5	ADDED	CCNT	2 NC 15	INSERVICE	INSPECTION	REV. 11
4	REVISE	NOTE (FAB SHOP WELD) FROM WELD 17	ISO NO: MCFI-2 NC 15	BUILDING: REACTOR ZONE R-22		
3	ADD	SYMBOL TO FIELD WELDS MADE IN FAB SHOP	DUKE PIPING CLASS: A-ASME B.P.V. CODE SECT. III	SYSTEM SYMBOL: NC-REACTOR COOLANT		
2	REVISED	SPECS ON MAT. 'F' PER PIPING SPEC.	PIPING SPEC: NC 06 PS-2501.1	DRAWING NO: MC 2414-03.20-00; 01 EL. 725'-0"		
1	DELETE	WELD NCFW 15-24 PER LAYOUT	PROJECT	MCGUIRE		
0	RELEASE	FAR CONSTRUCTION VU # 16717	ORIG. CHKO. APPR.	DATE		
NO	REVISION	G.A. CONDITION 1	DATE	DATE

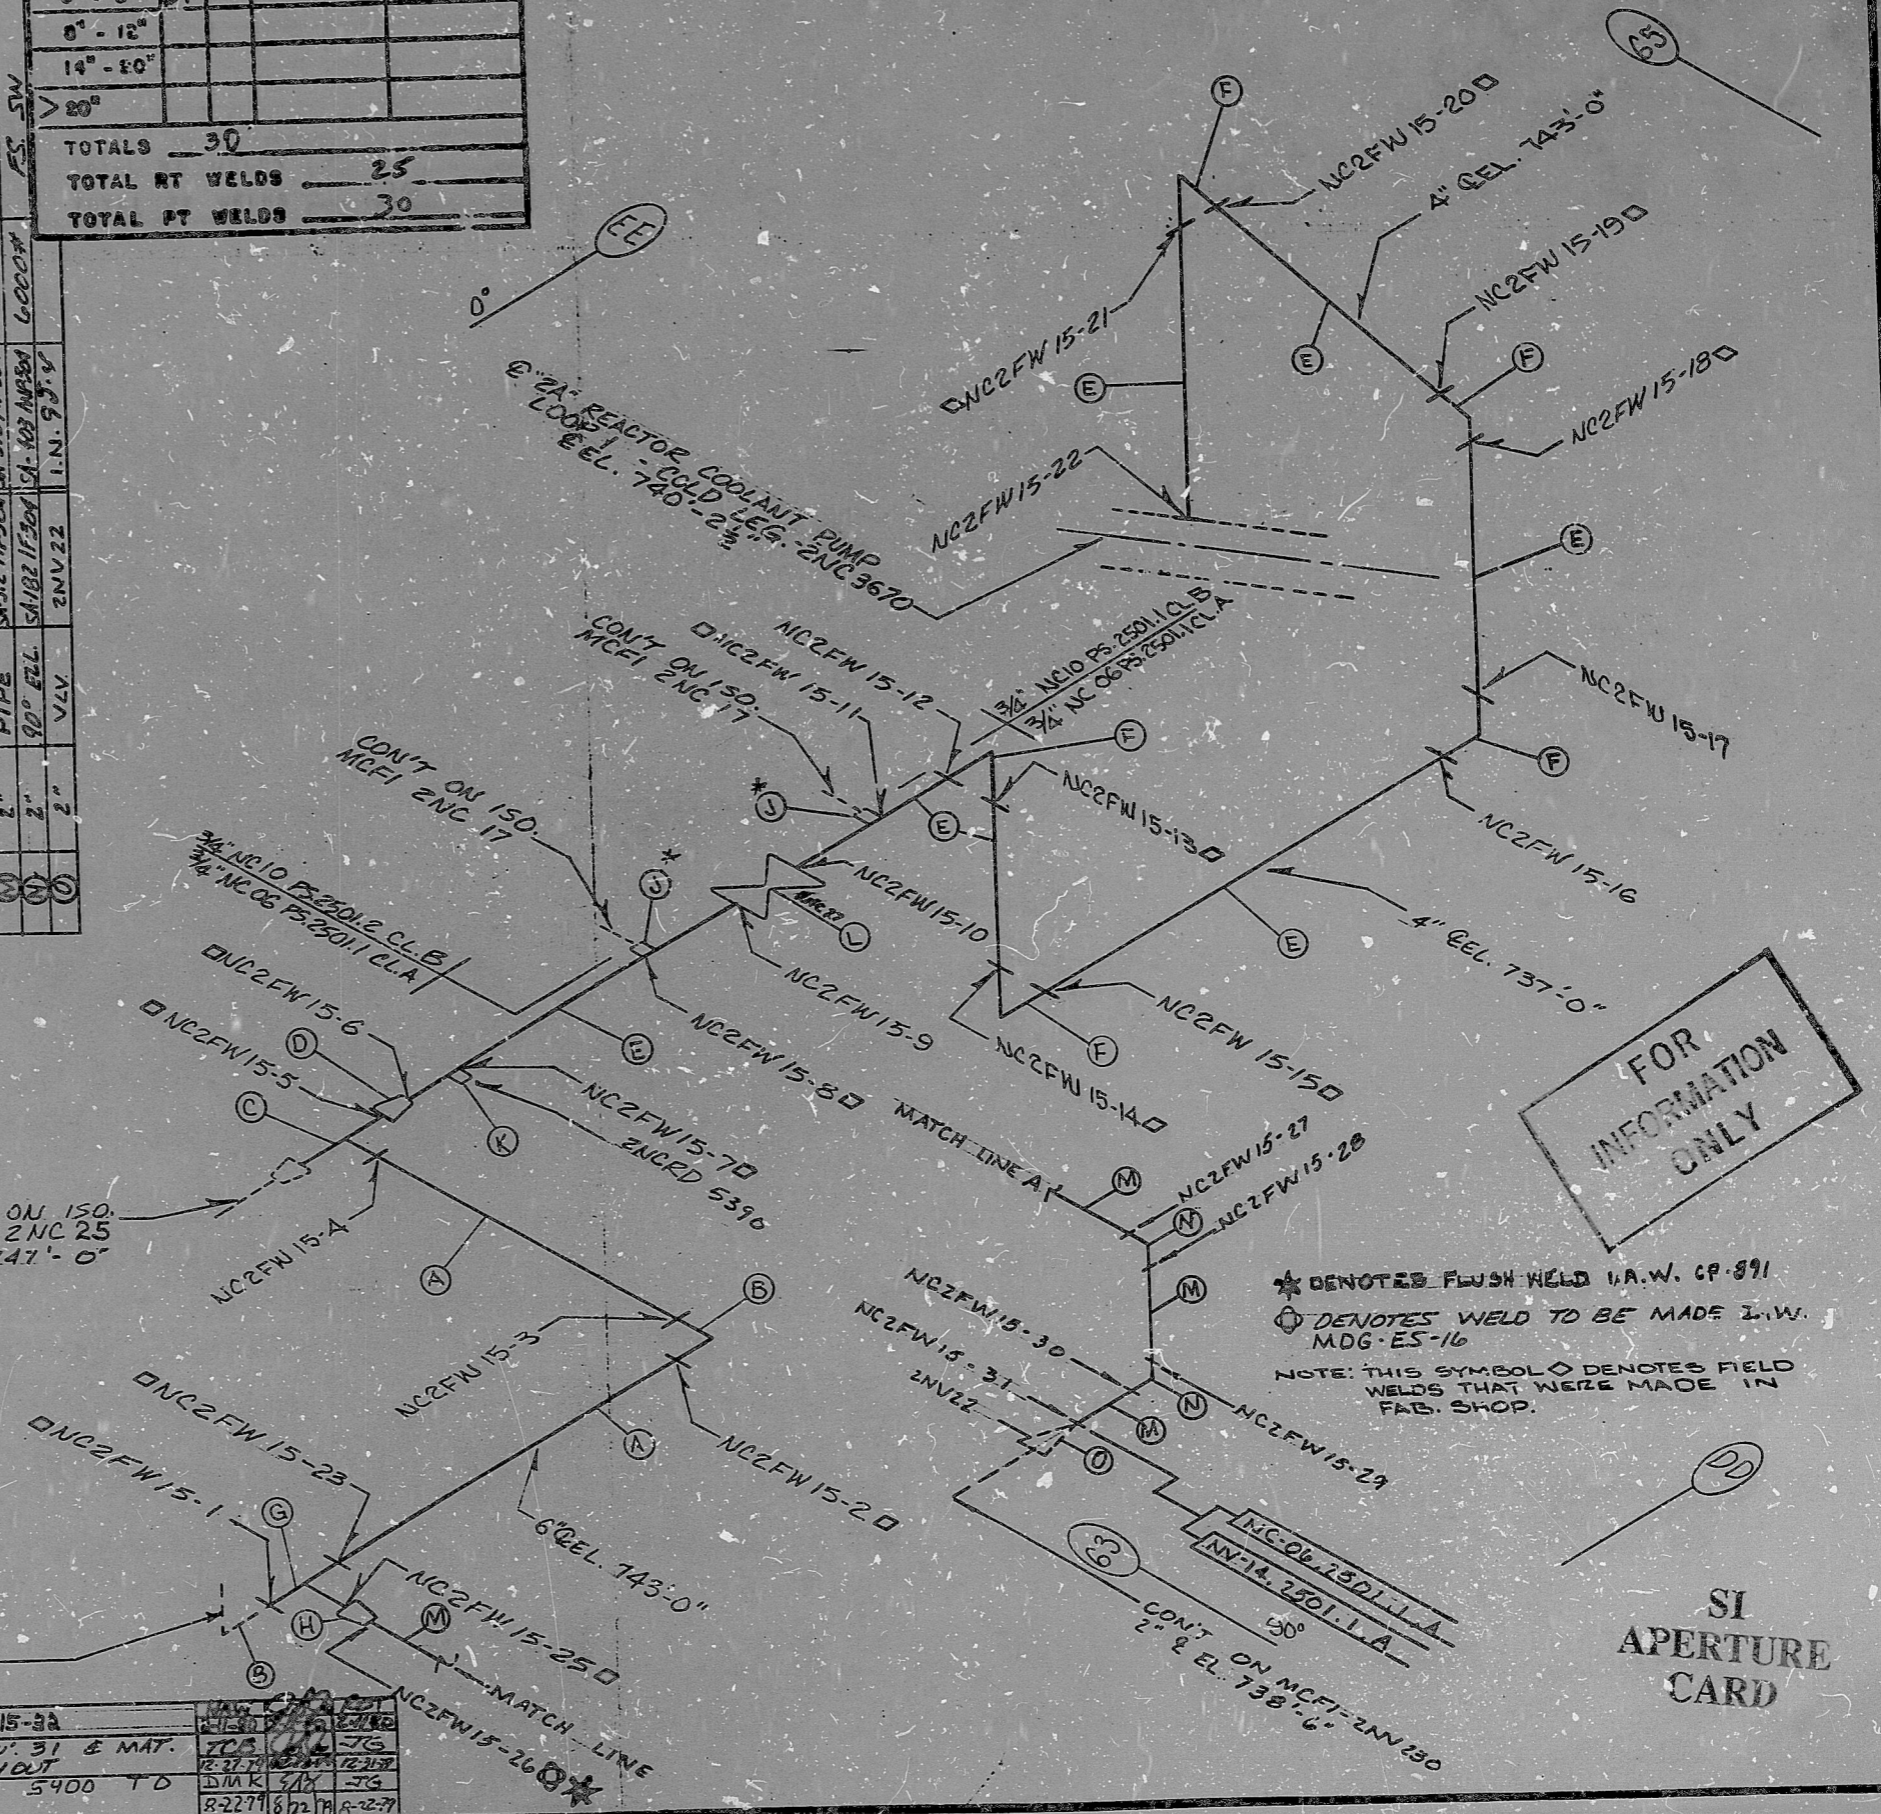
- 9 DELETED WELD NO. NCFW 15-32
- 10 DELETE SEC. 01 FROM TITLE BLOCK
- 11 ADDED NOTE FOR FLUSH WELDS
